# REPORT TO THE SUBDIVISION AND DEVELOPMENT APPEAL BOARD

| **DATE: August 11, 2026** | **APPEAL NO.: SDAB2026-01358**<br>**FILE NO.: DP2026-0113** |
| **FROM A DECISION OF THE DEVELOPMENT AUTHORITY where a**<br><br>**New: Rowhouse Building (1 building), Semi-detached Dwelling, Secondary Suite (5 suites), Accessory Residential Building (garage)**<br><br>**was approved at 3858 (previously 3840) Brighton Drive NW.** | **LAND USE DESIGNATION: R-CG**<br><br>**Discretionary** |

A001

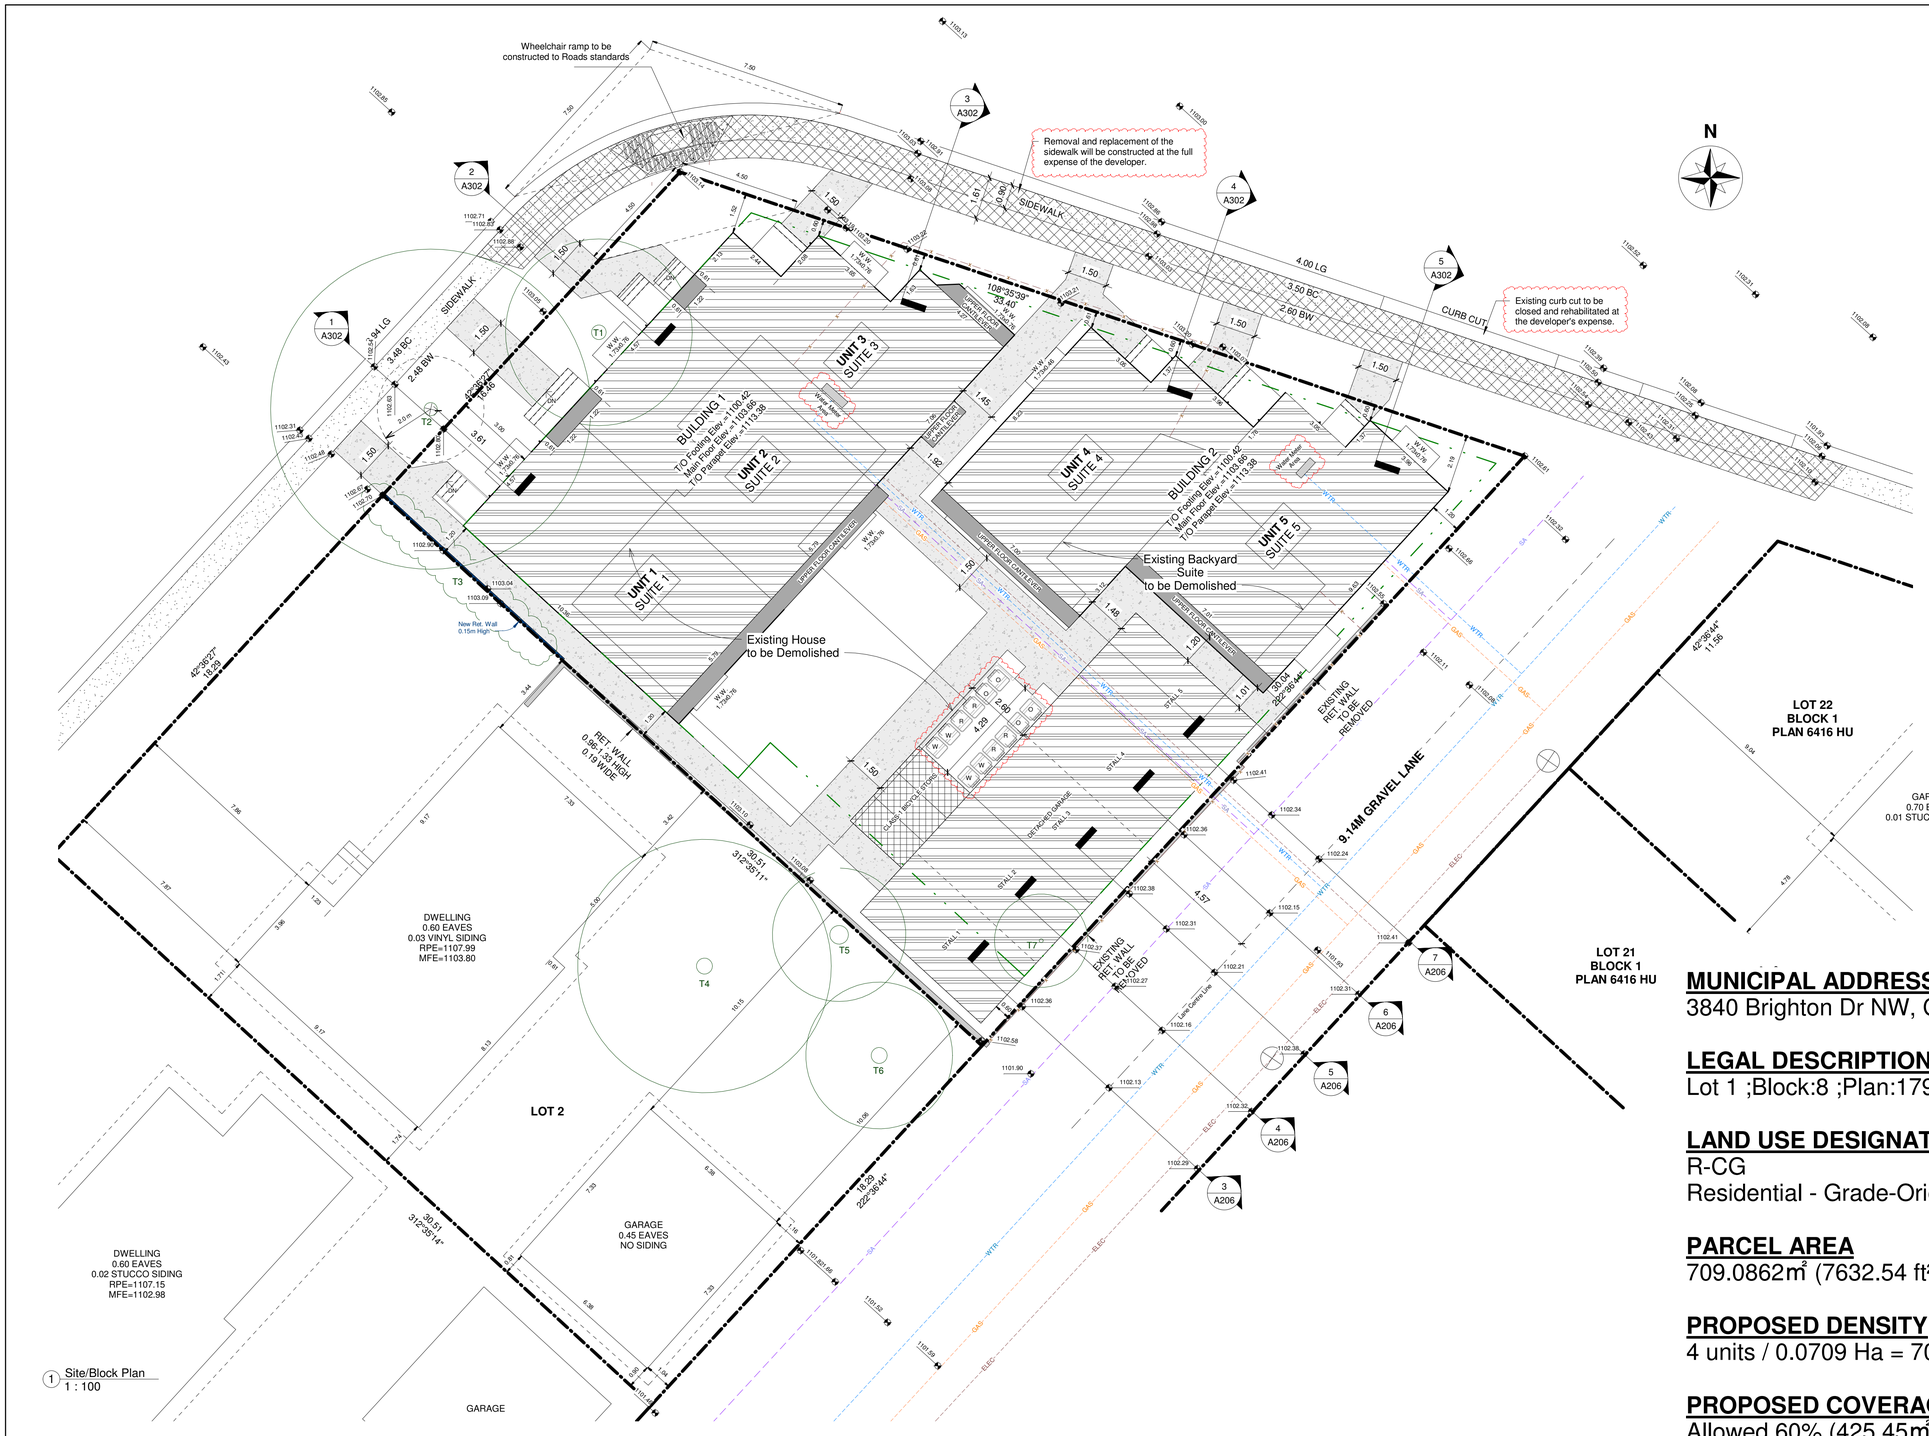
The amended plans make no change to the parking provision. The Bylaw Study on Sheet A001 continues to show only 5 garage stalls and 6 bicycle spaces for a development that, on the face of the title page, proposes 10 dwelling units. Even if the unit count is ultimately confirmed as 4 primary units (as suggested by the site plan), this would still yield a parking ratio of 1.25 stalls

2. Parking Deficiency
The Bylaw Study included in the submitted plans (Sheet A001) identifies parking provision of only 5 garage spaces and 6 bicycle storage spaces for a development proposing 10 dwelling units (5 primary units plus 5 basement suites). This yields a parking ratio of 0.5 stalls per dwelling unit, which is significantly below what is needed to serve residents of this development.

A003

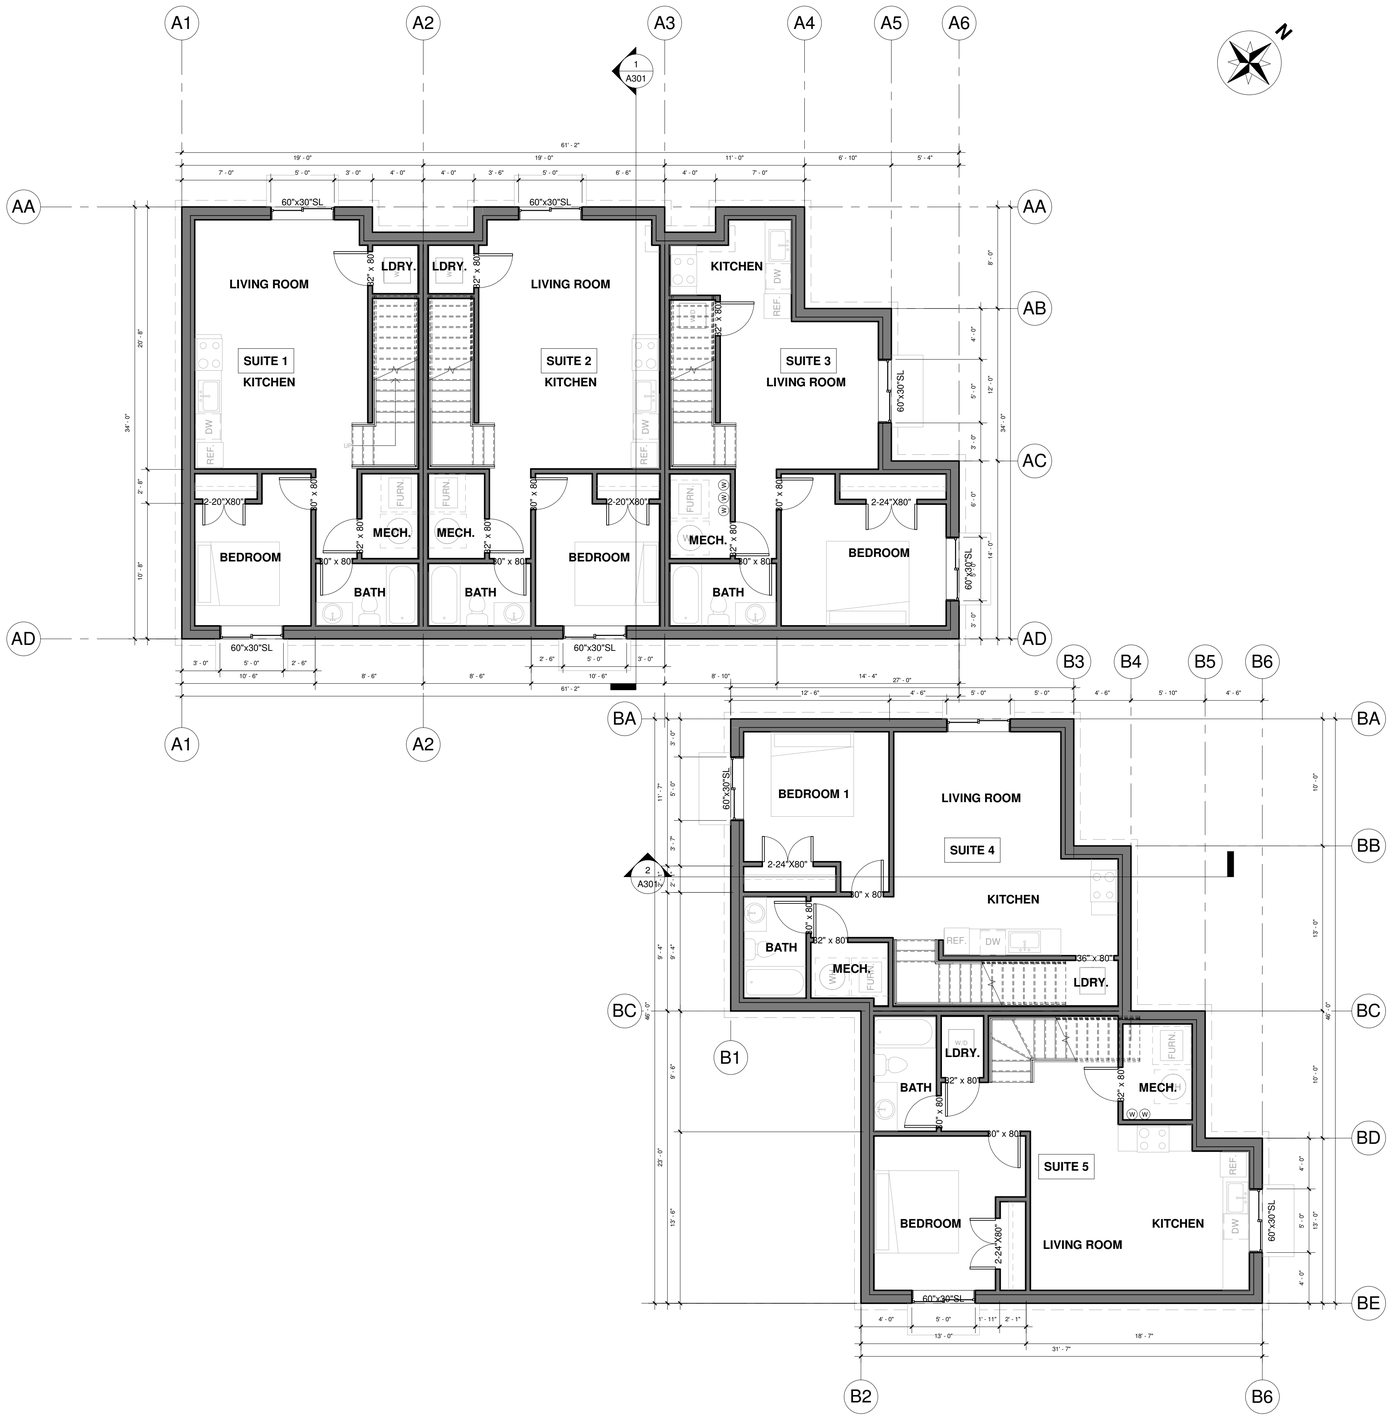
4. Removal of All Existing Trees
The Landscaping Plan (Sheet A003) shows that all seven existing trees on and adjacent to the subject property ¿ including trees T1 through T7 ¿ are proposed for removal. This includes trees identified as being located in City property and on adjacent property lines. Several trees have significant canopy spreads (up to 14 metres) and trunk diameters indicating maturity.

A206

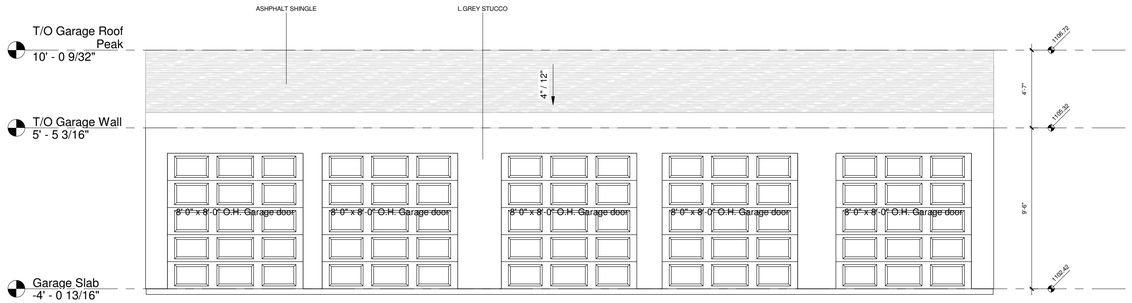
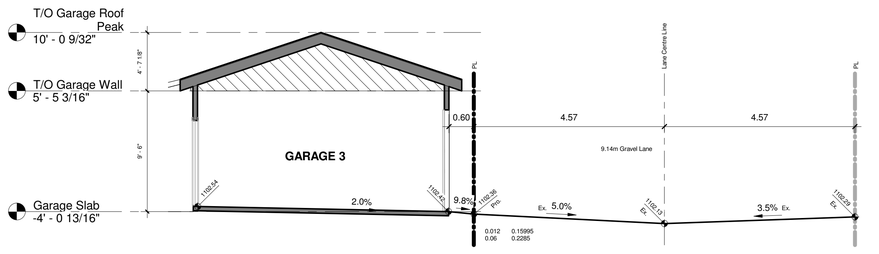
10 x 96G waste carts, appears to be 7 ½ on Garage North Elevation drawing A206. There is no extra space on this plan so there is not enough space for the minimum required waste bins. They appear as 10 carts on Landscaping plan A003 but aren't the same number on both plans. Which is correct? Note that A206 has 3-man doors on the Garage North Elevation (with two garages not having man doors) and not a lot of space for the waste carts. Note the walkway between Unit 4, 5, and Garage 5 is 4 feet wide concrete and an overhang, with no areas for snow clearing or obstacles. The 5 feet wide concrete walkway and partially covered between Building 1 and 2 (not illustrated in the elevations), also has no areas for snow clearing or obstacles and would require pickup parking on the already busy Brighton Drive N.W.
